HORNSEY TOWN HALL

S96

DESIGN DOCUMENT

20th February 2026

3670-KDS-TH-ZZ-DR-A-05-2202

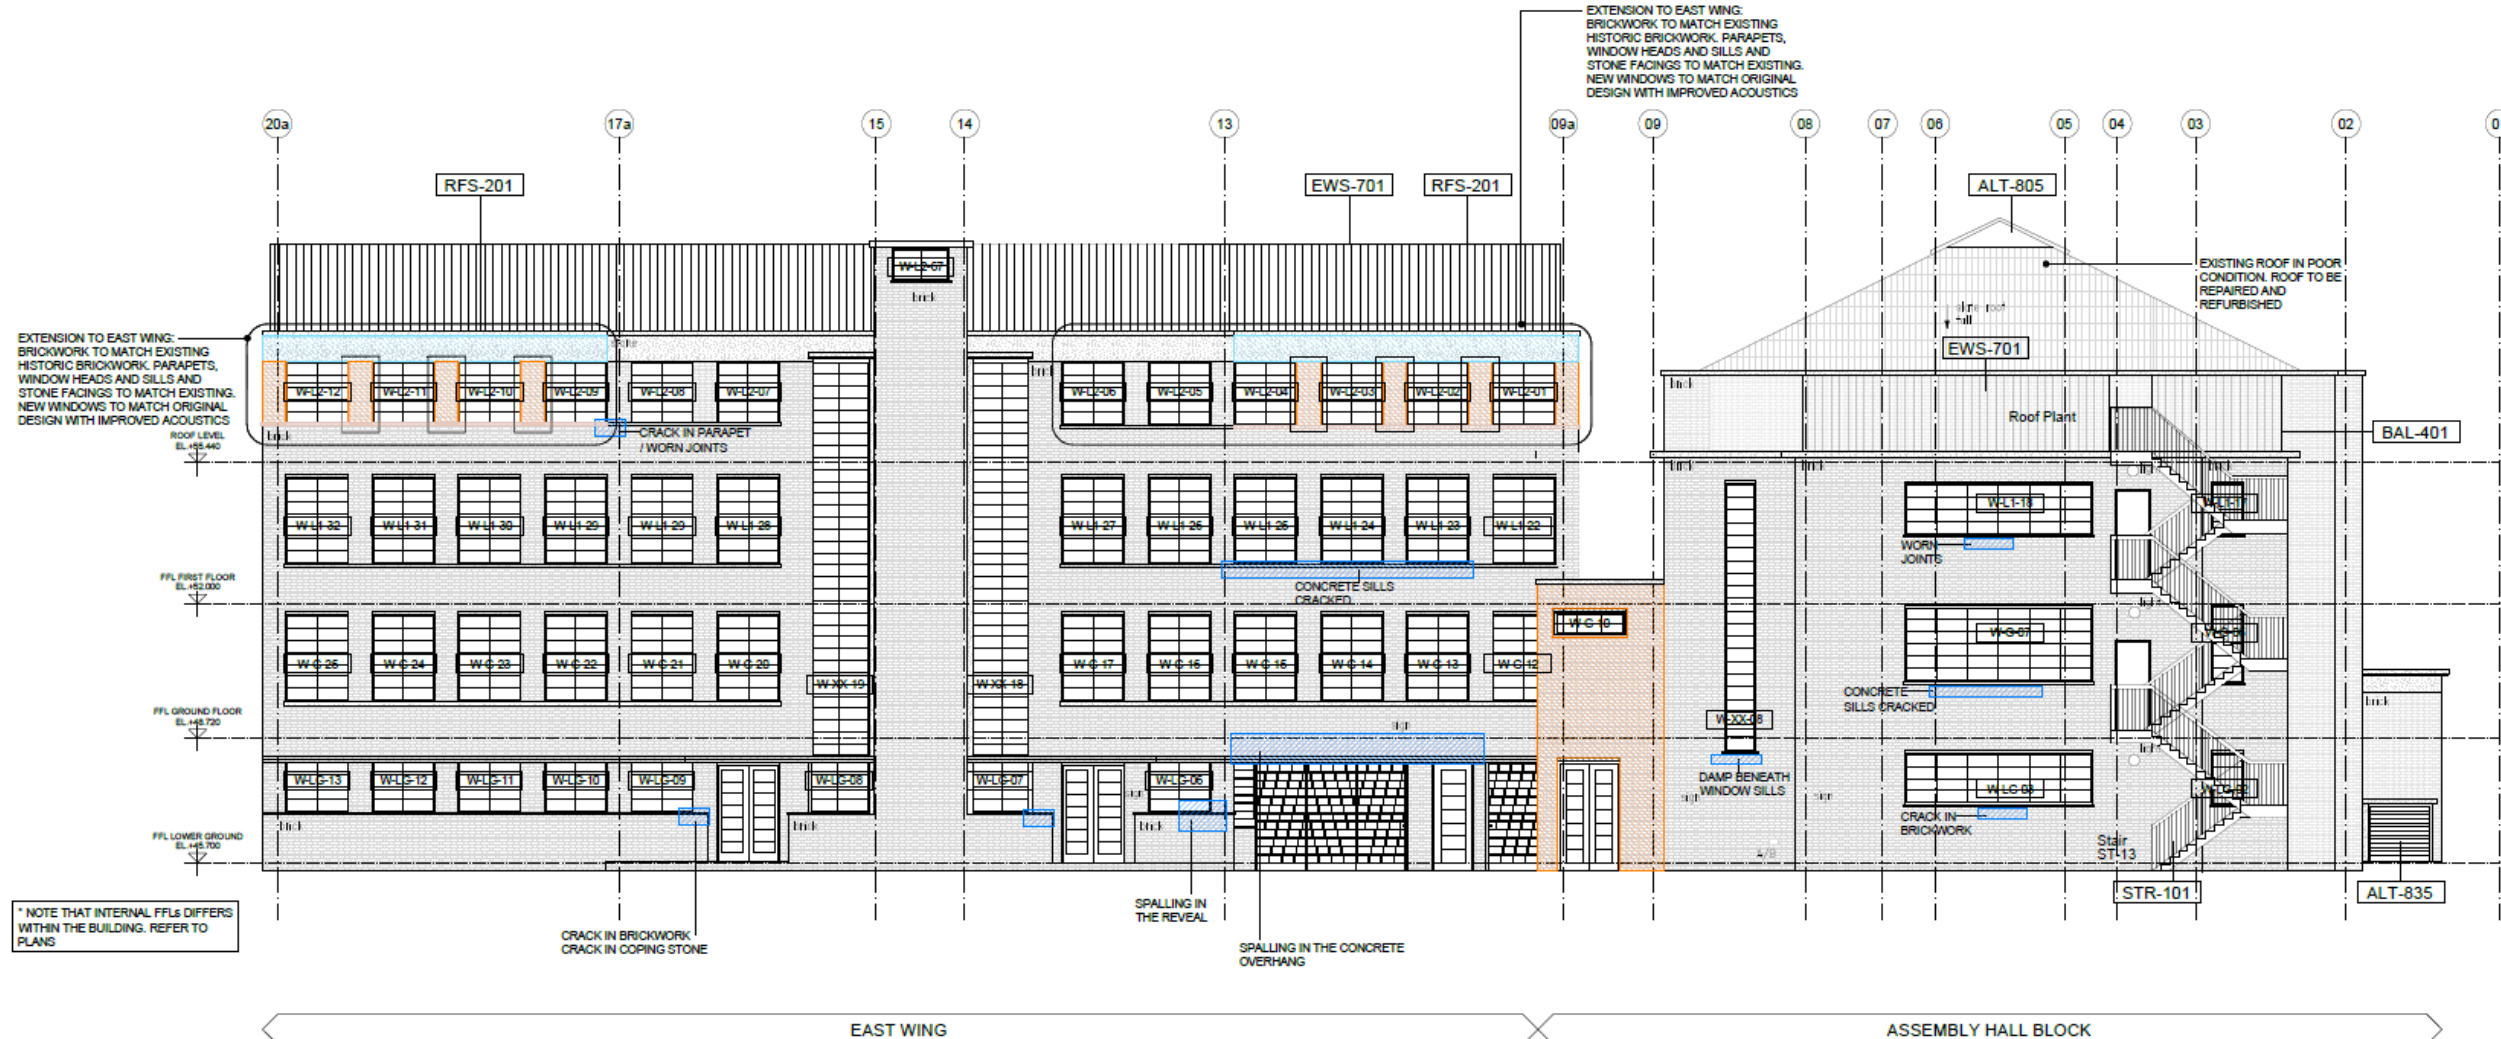
- Edge of the screen enclosure is extended between grid lines 07&08 and 13&14

Detail of proposed screen on roof

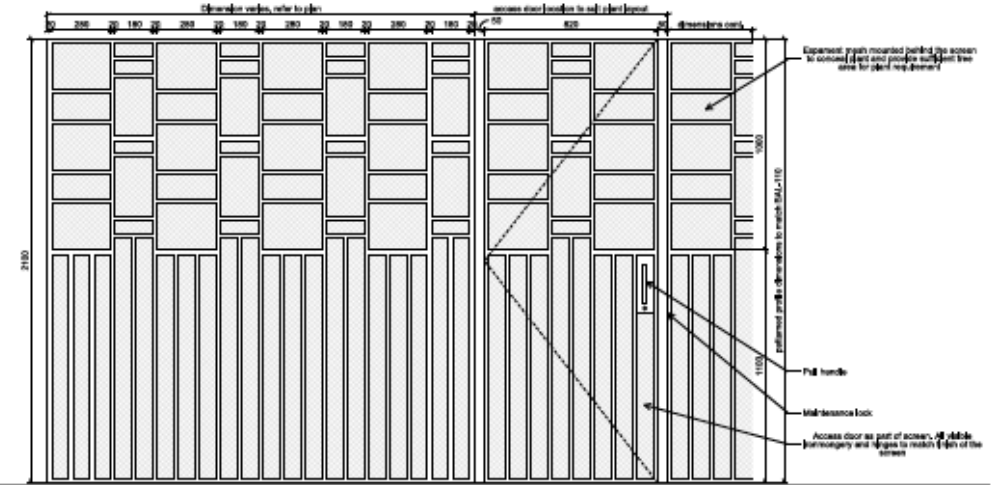
The detailing of the screen reflects the new metal balustrading proposed in the Town Hall which has been inspired by the 1930s metalwork in the building. A fine mesh is integrated within the screen and this prevents visibility of the plant equipment through the perforated detail.
